MODEL	
2014-2017MY	
Forte (YD)	
2017MY	
Forte (YDm)	
DATE	
January 2018

TECHNICAL SERVICE BULLETIN

STEERING GEAR YOKE PLUG AND ASSEMBLY REPLACEMENT

This bulletin provides the procedure to replace the steering gear box yoke plug and assembly on some 2014-2017MY Forte (YD), produced from February 18, 2013 through November 15, 2016, and some 2017MY Forte (YDm) vehicles, produced from May 15, 2016 through February 9, 2017, which may exhibit a ticking noise while turning the steering wheel with the vehicle stopped or a rattle noise while driving. This condition is caused by a worn lining on the steering gear box yoke assembly. Follow the procedure outlined in this bulletin to replace the steering gear box yoke plug and assembly with updated parts.

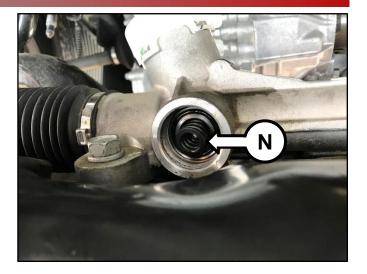
Using the provided 24mm hexagon bit socket, remove and discard the yoke plug (L).

When loosening the plug, ensure the <u>24mm socket is</u> straight and flush with the plug at all times. Forcibly loosening the plug with the socket at an angle and rubbing on the subframe as shown (M) may damage the housing threads. Continue to loosen the plug by hand.

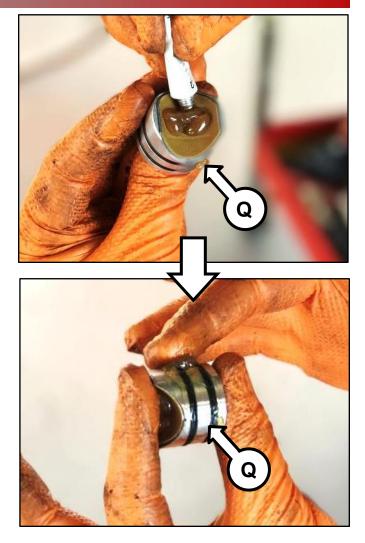
12. Remove the yoke assembly (P) and discard.

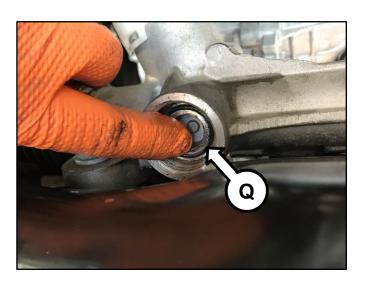
13. Apply lubricant to the bottom and on the O-rings of the new improved yoke assembly (Q).

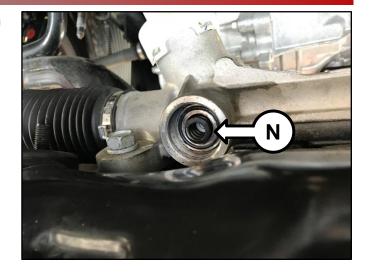
14. Install the improved yoke body (Q) into the yoke housing.

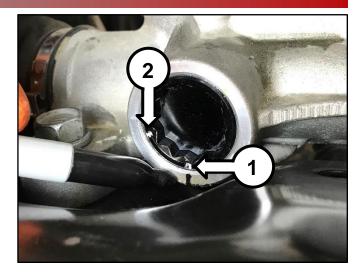
16. Partially install the new yoke plug (R) by hand to prevent cross-threading of the plug and housing threads.

17. Tighten and torque the yoke plug (R) to specifications.

Tightening torque for plug (R): 36.2 lb.ft (49.0 N.m, 5.0 kgf.m)
